MEMORANDUM

SUBJECT: SP21-064; Douglas 234 F6 L2 - Car Wash
Review Comments 01

CARWASH SITE PLAN

LOT 2 OF DOUGLAS 234 FILING NO. 6

DATE	
BY	
REVISION	
No.	
 501 S Cherry St, Suite 300 Denver, CO 80246 303.672.1997 www.ees-us.com	
SITE PLAN LOT 2 CAR WASH CHAMBERS AND HESS, PARKER, CO COVER SHEET	
PROJECT NO.:	TSD003.01
DESIGNED BY:	LCG
DRAWN BY:	JLG
DATE:	05/27/21
P0.0

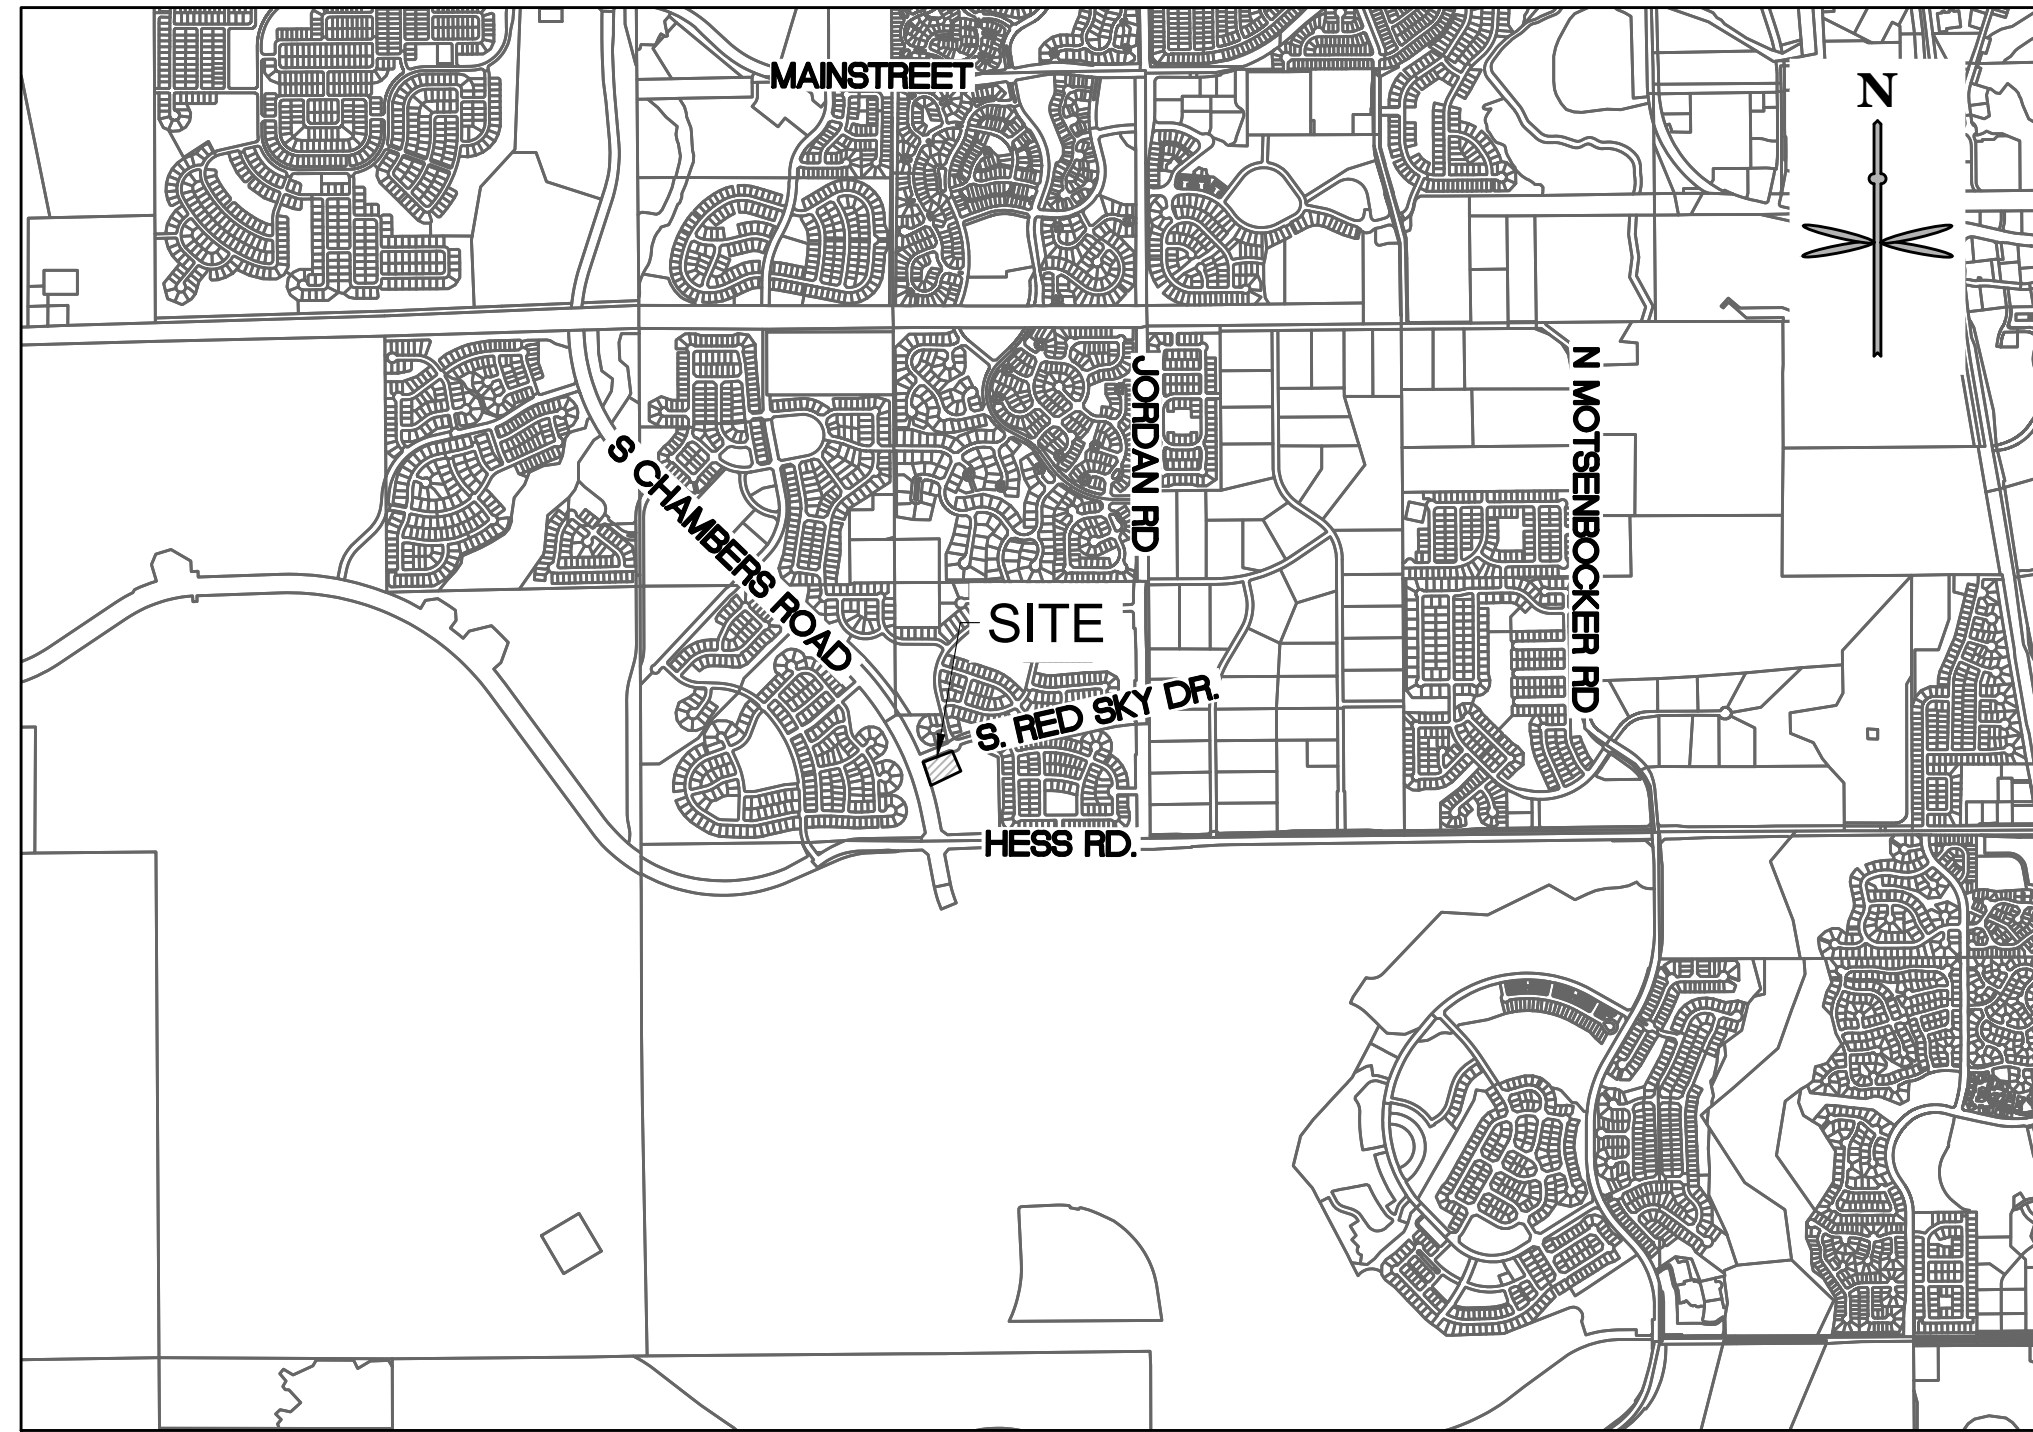
The Legal Description needs to be the main title-switch 1st and 2nd lines
COMPLETED

what is labeled side is actually front, revise
COMPLETE

what is labeled rear is actually side-please revise
COMPLETE

Max FAR is 50%, where are you getting 25%?
<http://parkeronline.org/DocumentCenter/View/22897/52---Douglas-234?bidId=>
You still meet requirements but please revise max to 50
COMPLETE

North & south property lines are side yards

East is Front
West is Rear

Rear and Front face ROW and require 25'

North side and south property line require 10'

Revise to show accurate required vs. actual
COMPLETE

PROJECT NO: TSD003.01
DESIGNED BY: LCG
DRAWN BY: JLG
DATE: 03/19/21
P1.0

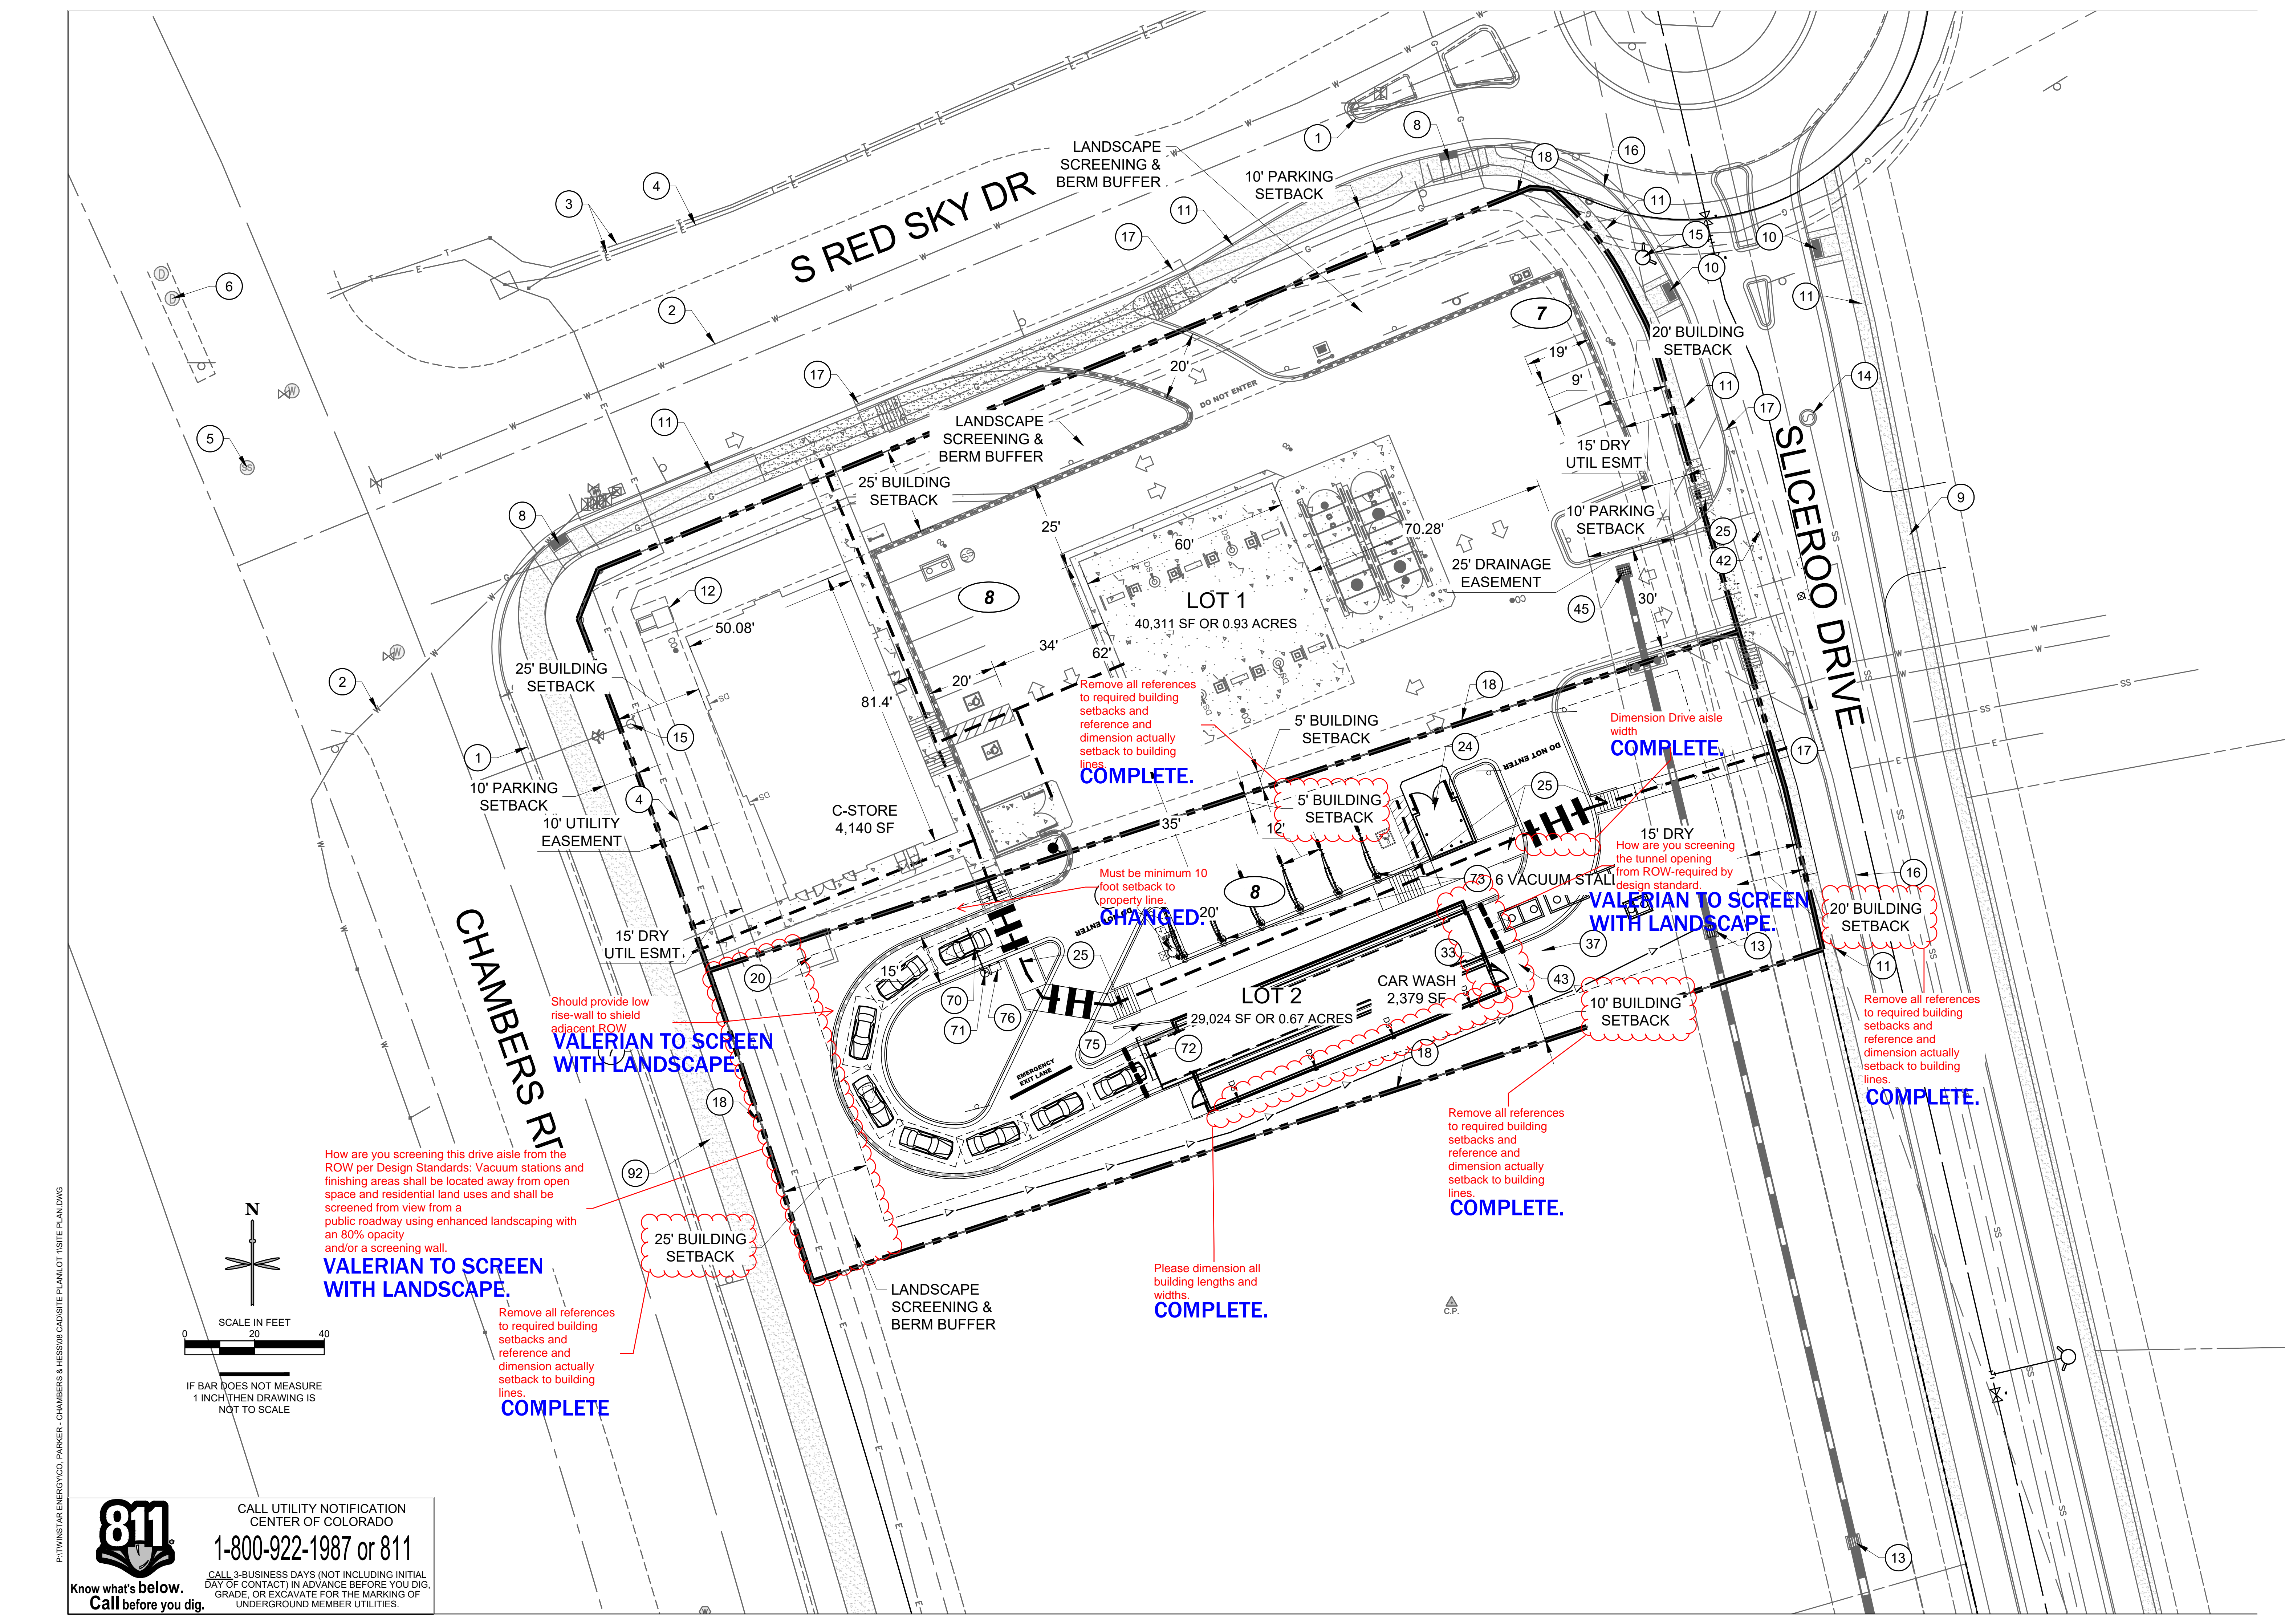
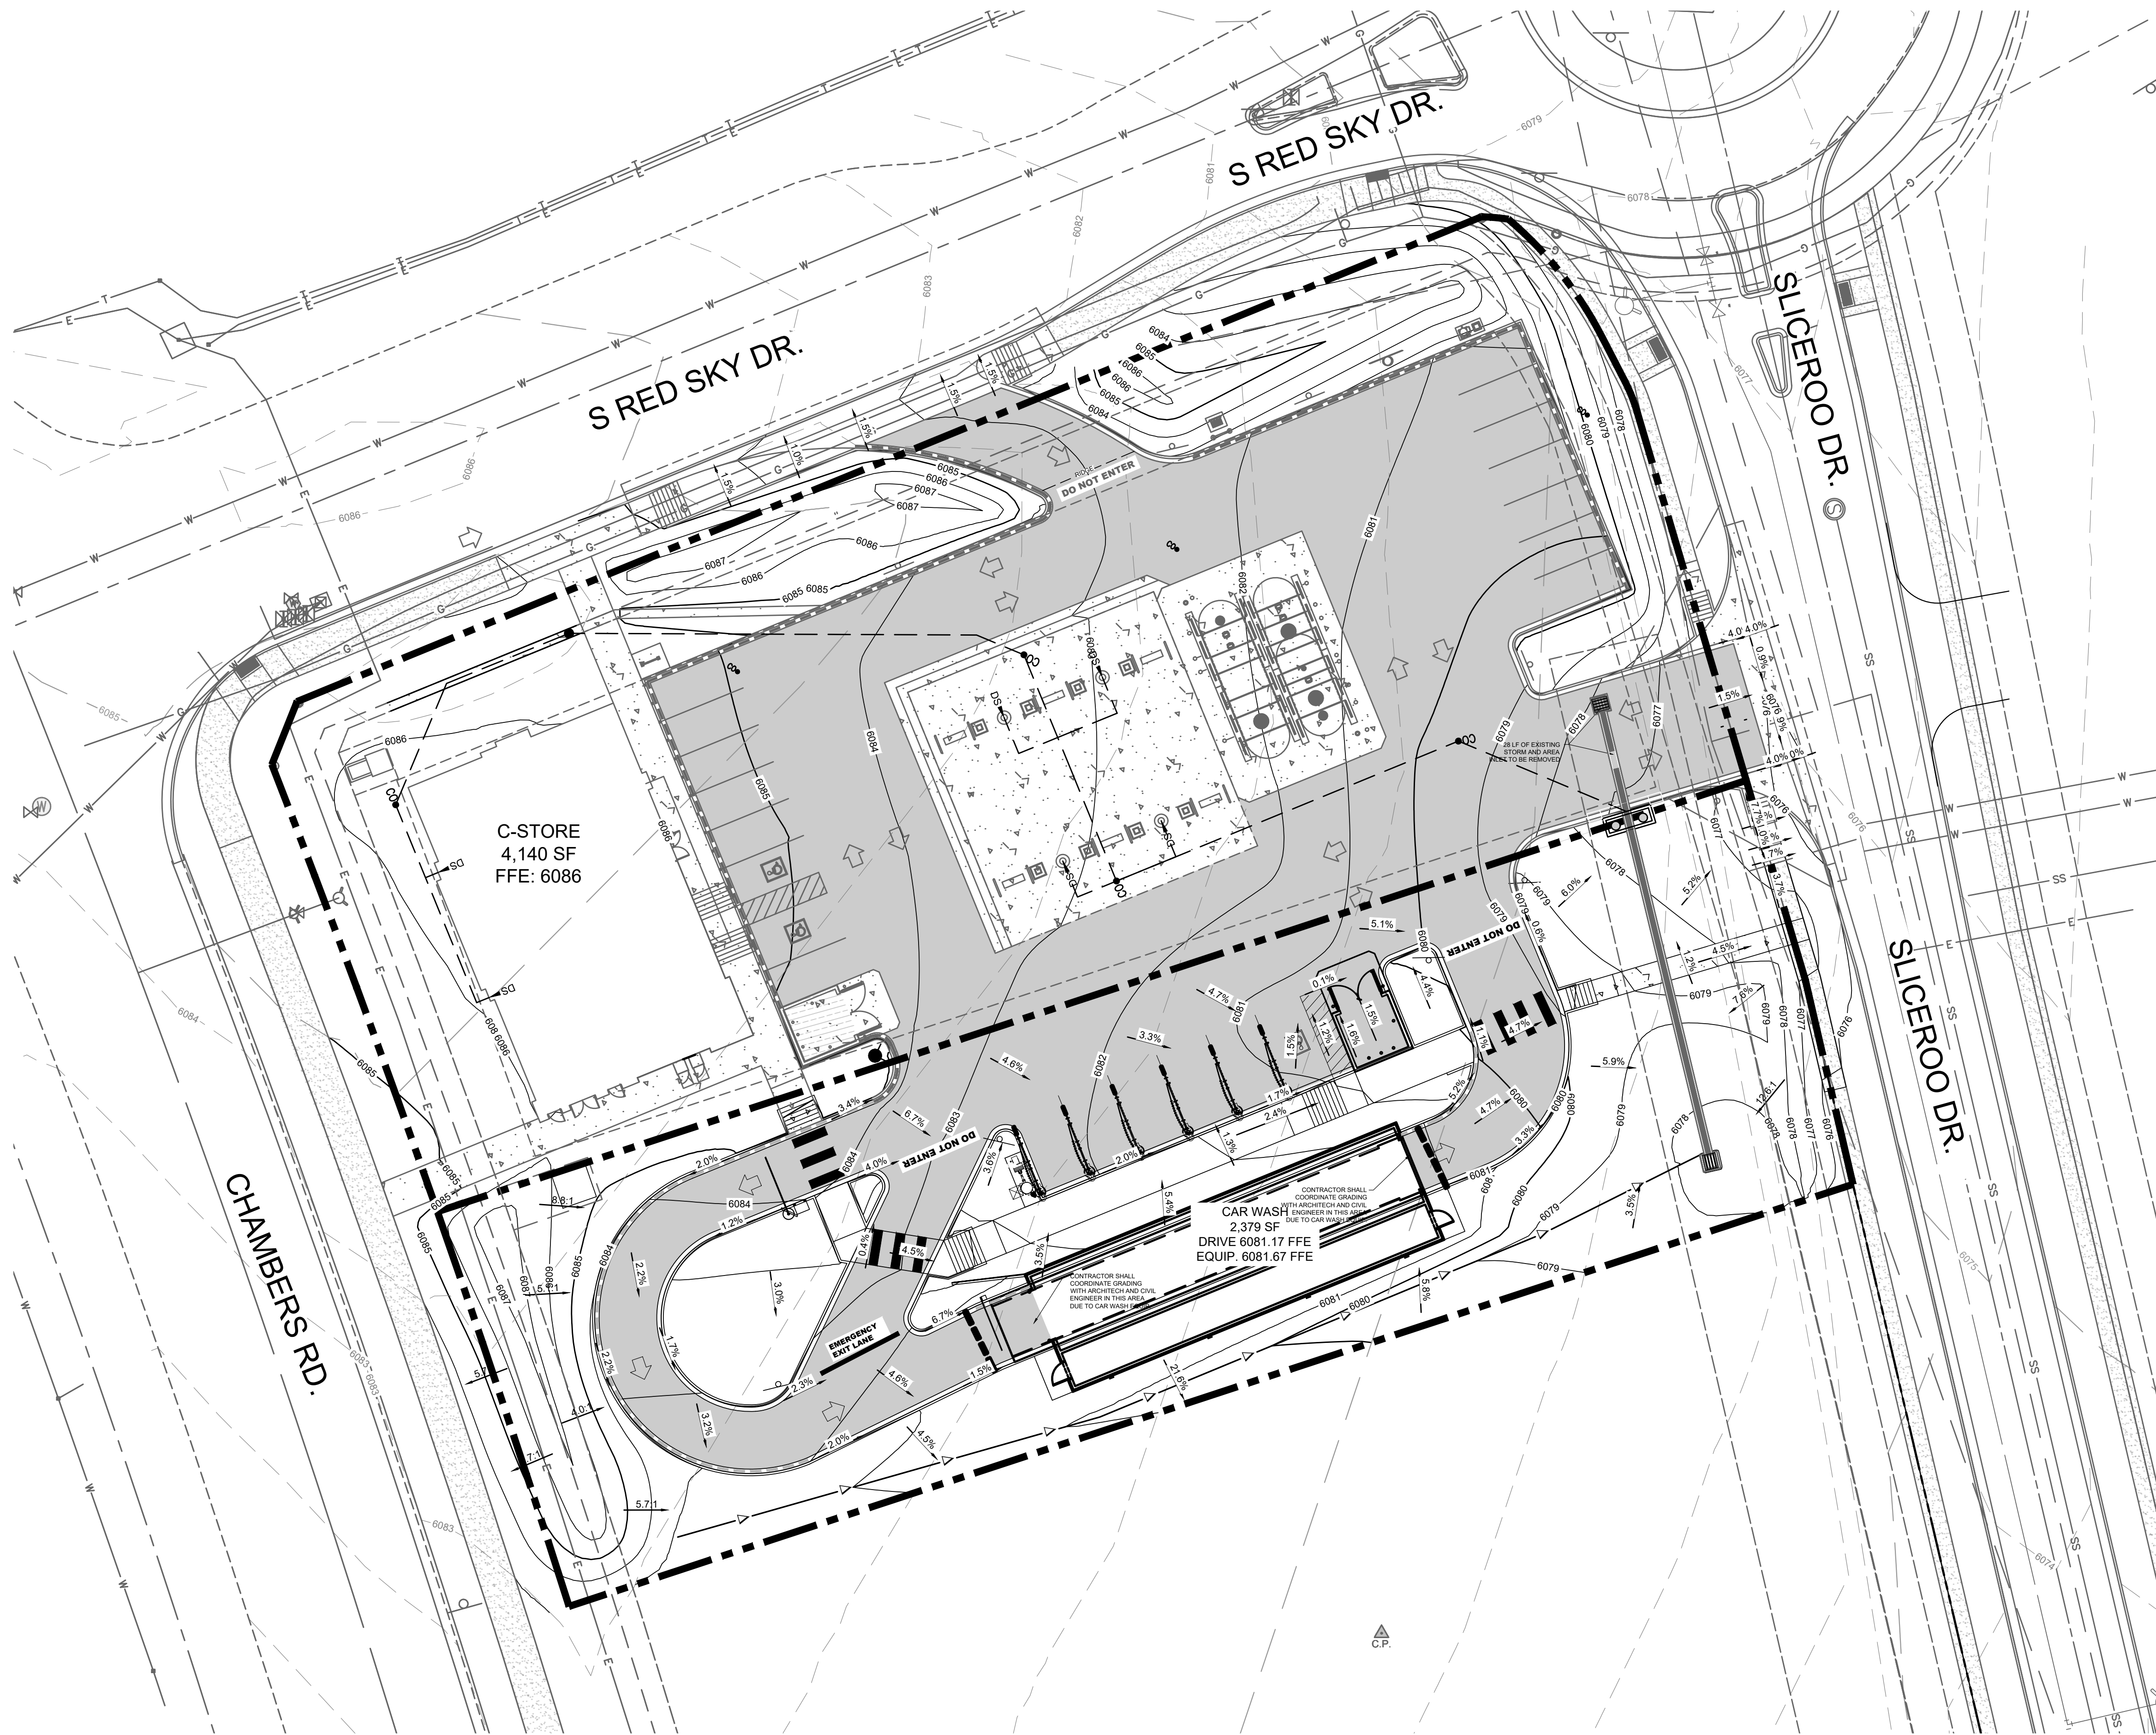
How are you screening this drive aisle from the ROW per Design Standards: Vacuum stations and finishing areas shall be located away from open space and residential land uses and shall be screened from view from a public roadway using enhanced landscaping with an 80% opacity and/or a screening wall.

Remove all references to required building setbacks and reference and dimension actually setback to building lines.
COMPLETE

Should provide low rise-wall to shield adjacent ROW
VALERIAN TO SCREEN WITH LANDSCAPE.

Must be minimum 10 foot setback to property line.
CHANGED.

Please dimension all building lengths and widths.
COMPLETE.

Remove all references to required building setbacks and reference and dimension actually setback to building lines.
COMPLETE.

Dimension Drive aisle width
COMPLETE.

Remove all references to required building setbacks and reference and dimension actually setback to building lines.
COMPLETE.

Remove all references to required building setbacks and reference and dimension actually setback to building lines.
COMPLETE.

VALERIAN TO SCREEN WITH LANDSCAPE.

VALERIAN TO SCREEN WITH LANDSCAPE.
